Agenda
Village of Arlington Heights
Design Commission
Community Room, 3rd Floor

Arlington Heights Village Hall
33 S. Arlington Heights Road
Arlington Heights, IL 60005
March 31, 2015
6:30 PM

MINUTES OF
THE VILLAGE OF ARLINGTON HEIGHTS
DESIGN COMMISSION MEETING
HELD AT THE ARLINGTON HEIGHTS MUNICIPAL BUILDING
33 S. ARLINGTON HEIGHTS RD.
MARCH 10, 2015

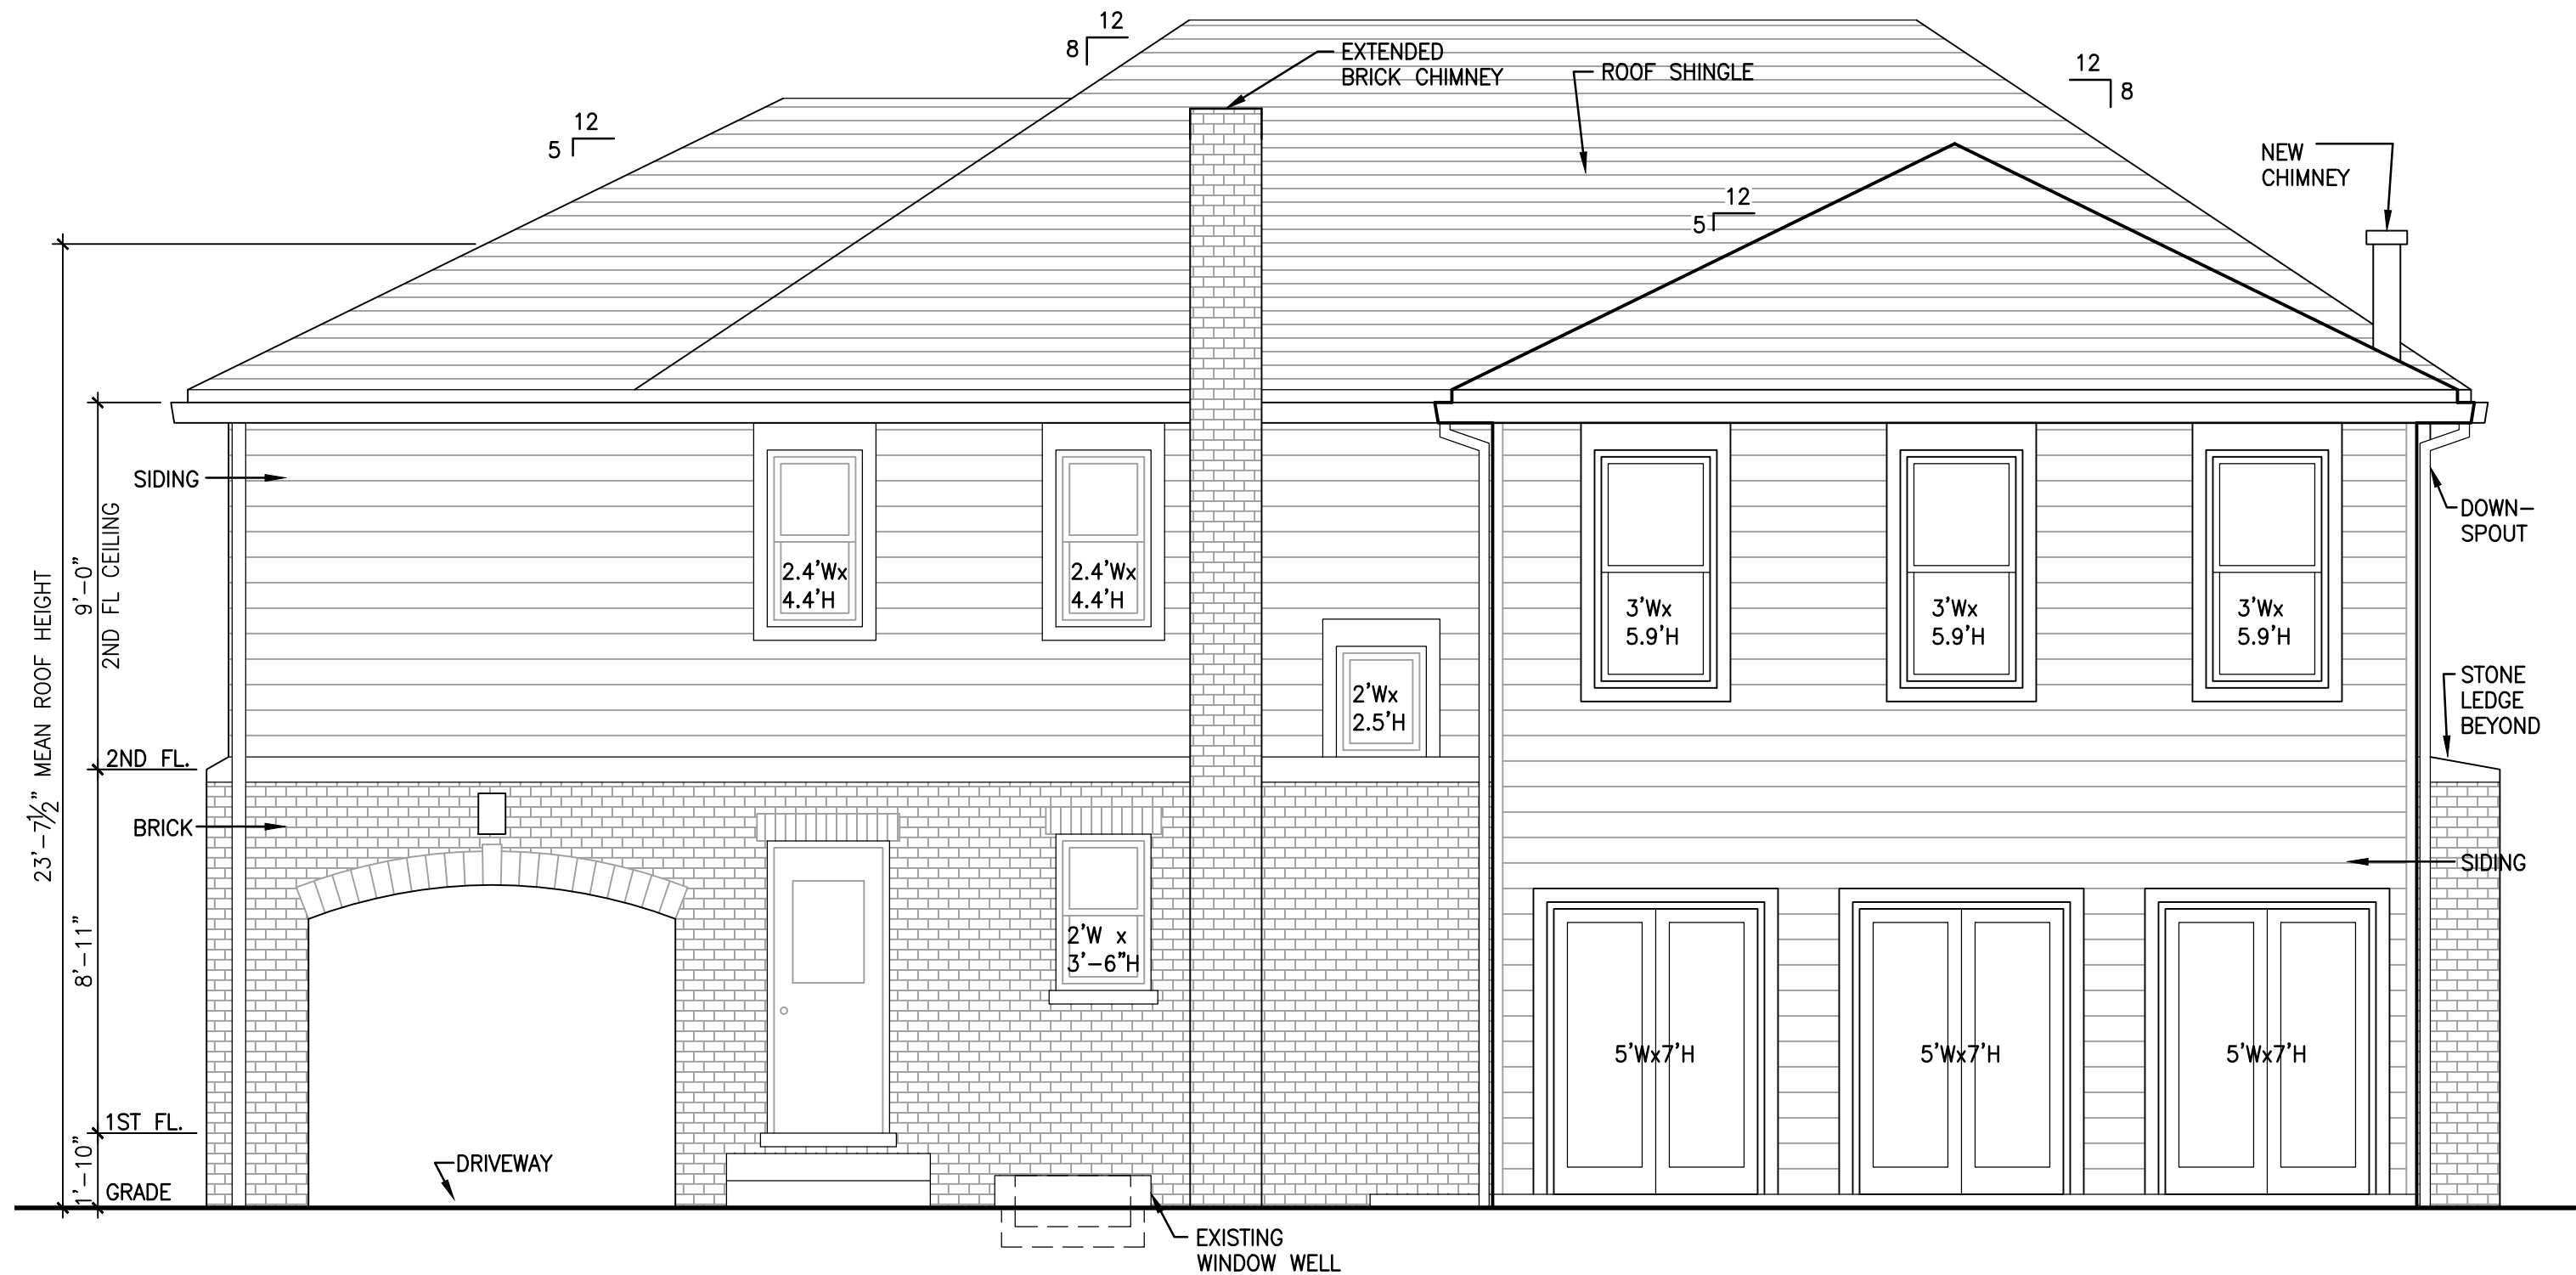
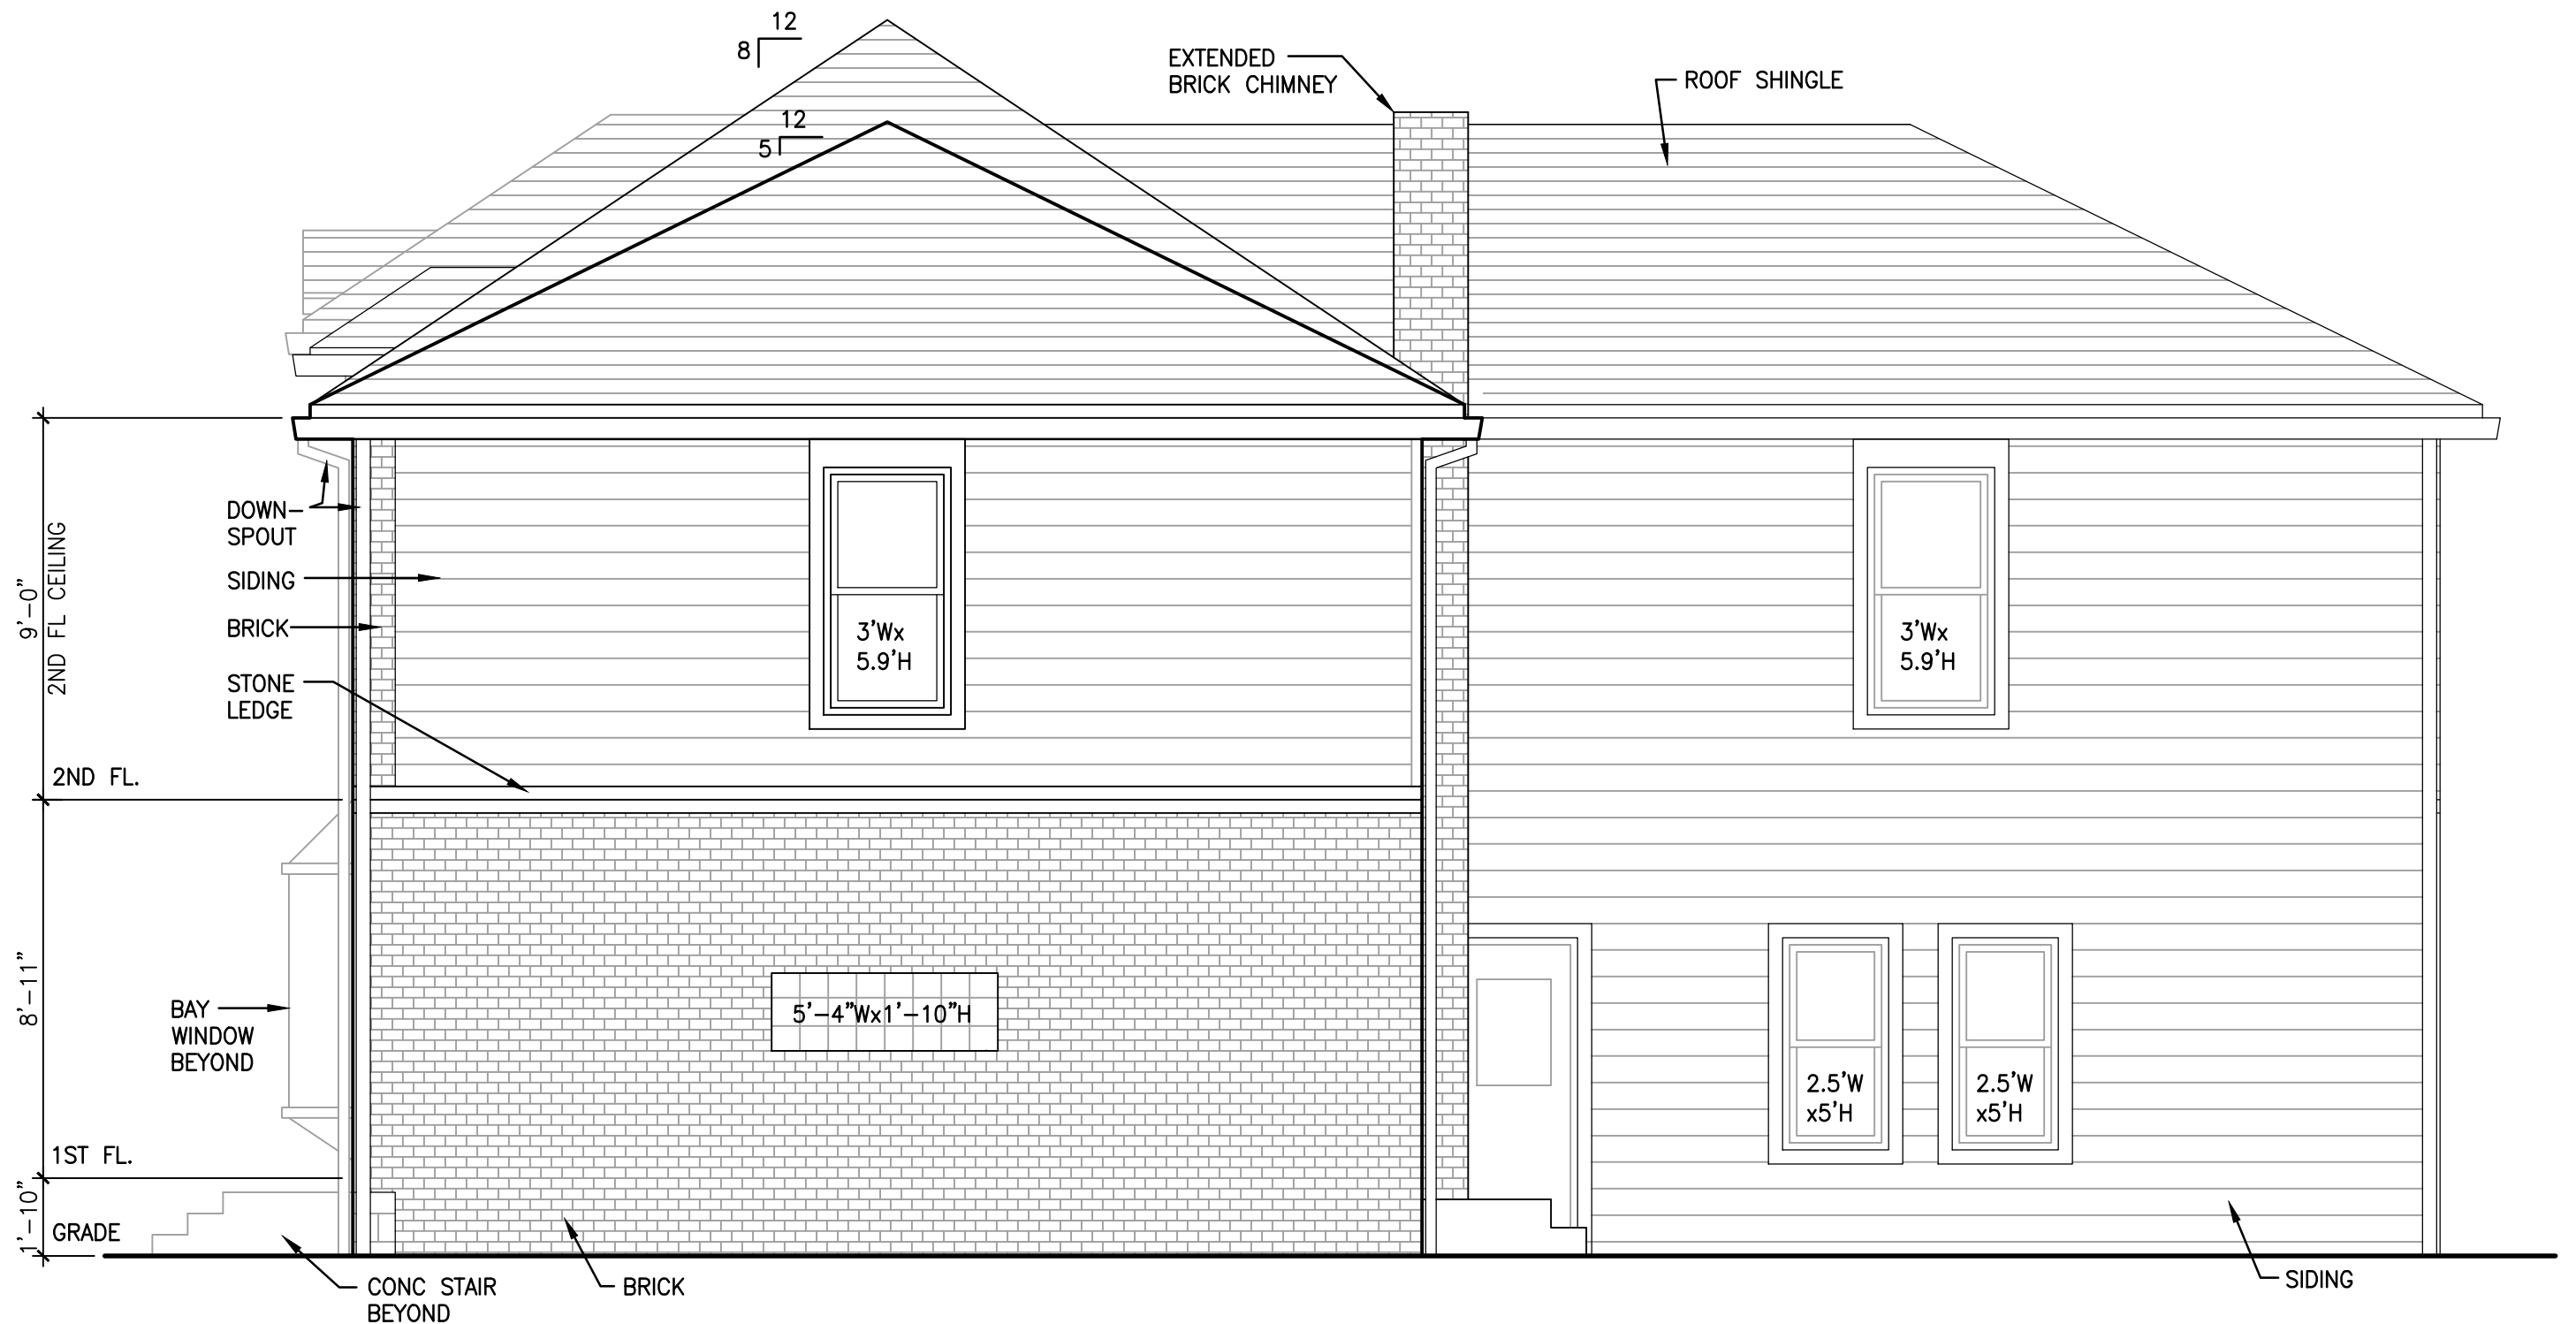
This project is a second floor and rear addition to an existing single story home, and it was previously approved on December 9, 2014 with a requirement, "to continue a horizontal trim board at the second floor line around all sides of the home." At this time, the house is under construction, and the petitioner is requesting approval to not add the horizontal trim board on the rear addition to the home, as well as to omit the horizontal stone trim band on all other sides of the home.

The stone band on the front elevation does help the design to relate to the adjacent single story homes, and the horizontal trim board on the rear addition helps to break up the two story wall of siding. However, this is a relatively minor detail on an otherwise nicely designed home.
